RSN:1762348 | PERMIT# 23-2396762-CM

THE RESERVES at EAGLE POINT

425 NORTH PICADILLY RD - BUILDING F

City of Aurora Building Division
Reviewed for Code Compliance
Approved as Noted: *Matt A.*
Date: *Nov 14, 2023*
2021 INTERNATIONAL CODES & 2023 NEC

3 SECOND FLOOR 3 BEDROOM HVAC PLAN
1/4" = 1'-0"

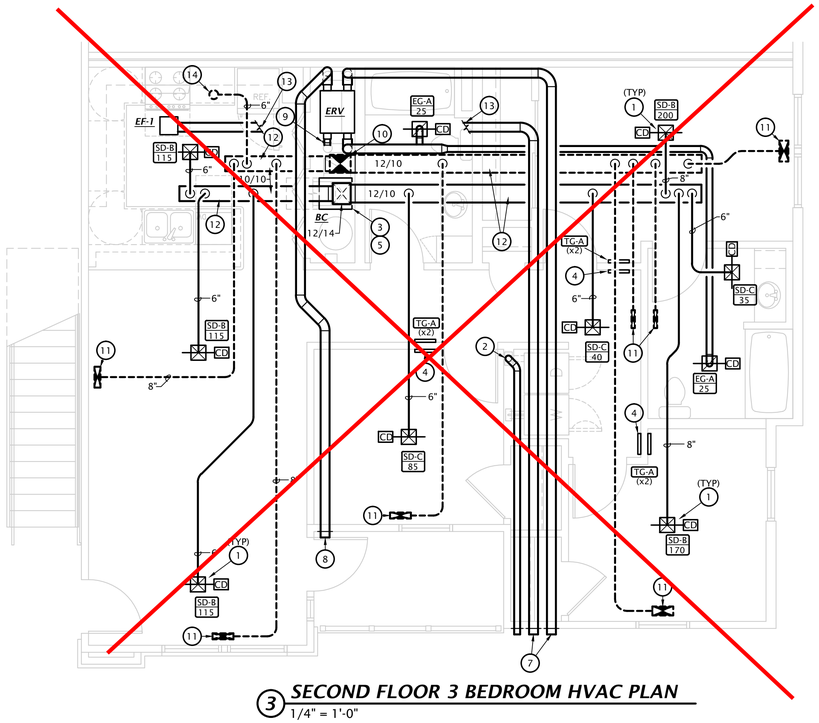
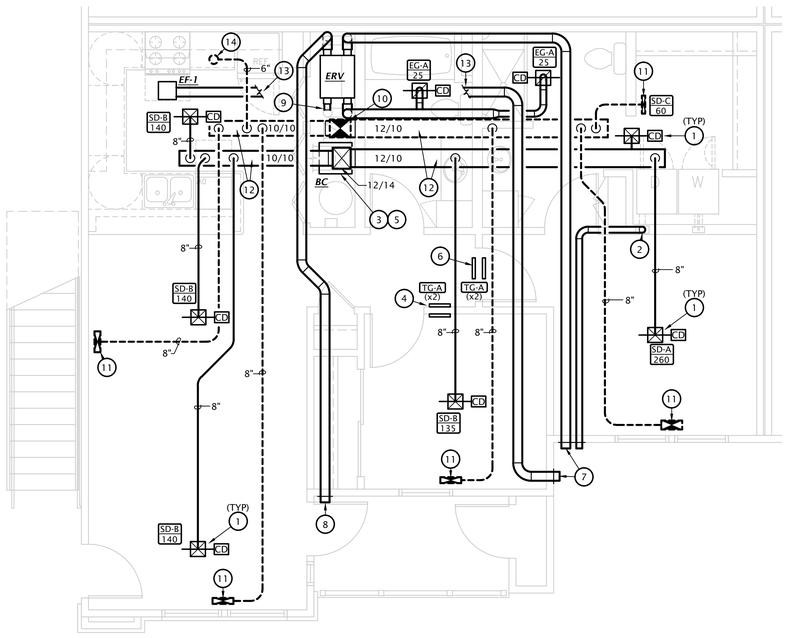
Provide proof of a flame spread index not more than 25 and a smoke-developed index not more than 50 for any material used in a plenum.
2021 IMC 602.2.1

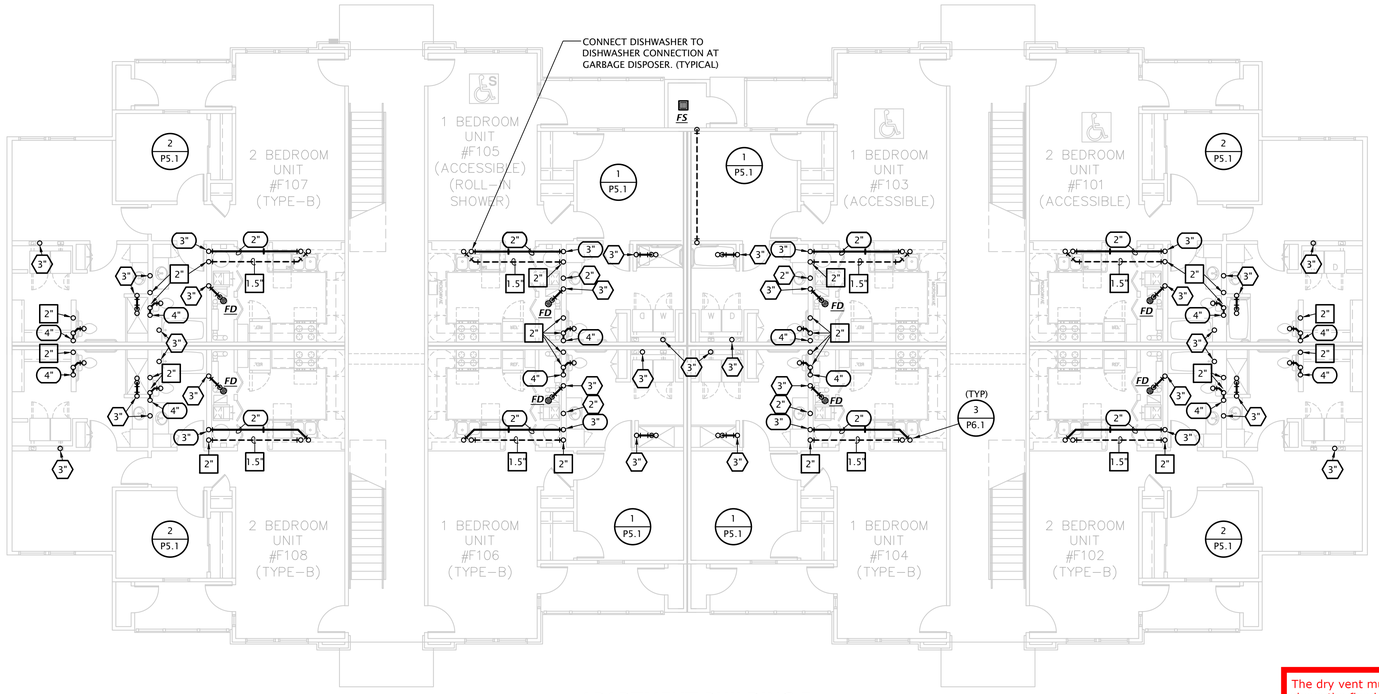
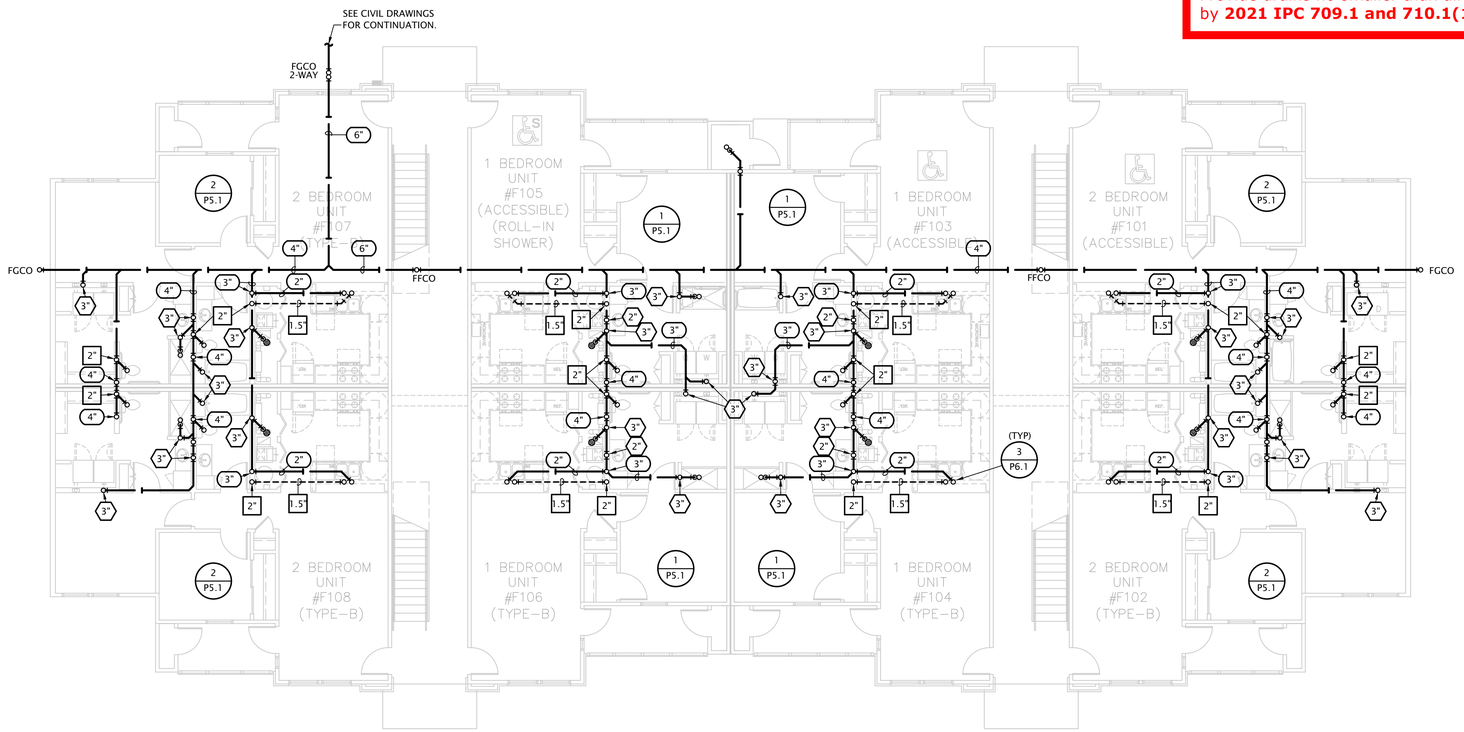
The dry vent must rise 6" vertically above the flood level rim of the highest trapped fixture being vented.
2021 IPC 905.4

Provide drains no smaller than allowed by **2021 IPC 709.1 and 710.1(1)**

APARTMENT BUILDING SERVICE GROUNDING ELECTRODE SYSTEM
3 No Scale

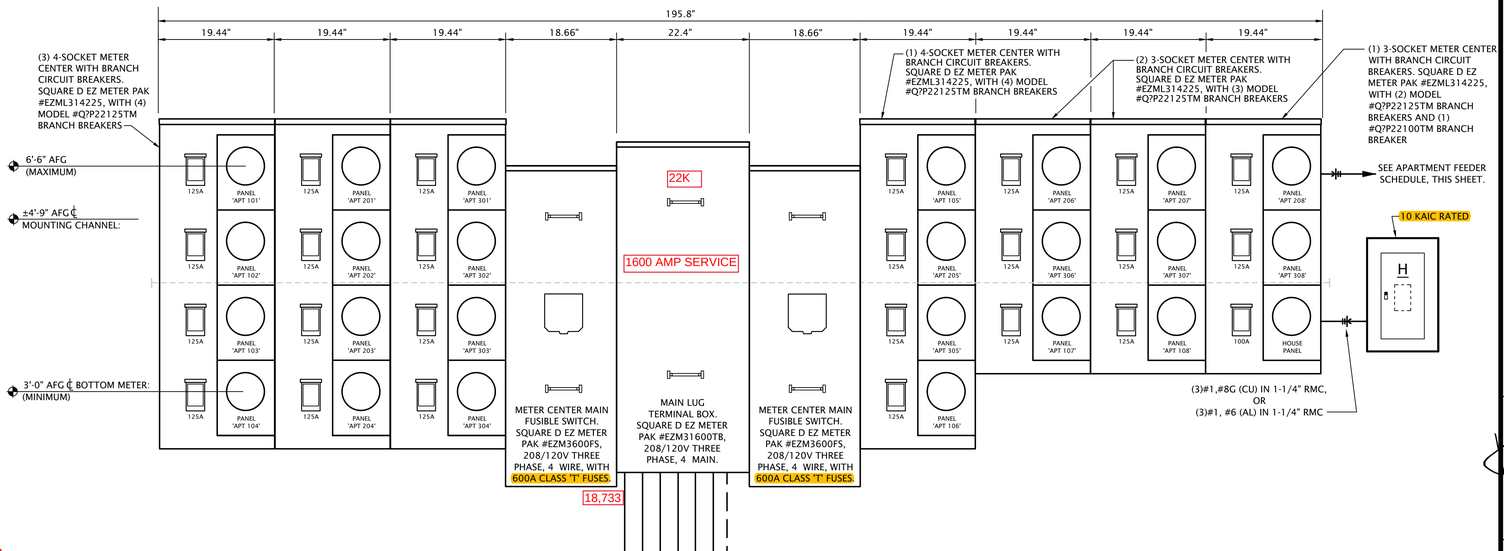
Same Vertical Section. Other than the required Interconnections and control wiring, only those conductors That are intended for termination in a vertical section of a switchboard or switchgear shall be located in that section. 408.3(A)(2) 2023 NEC
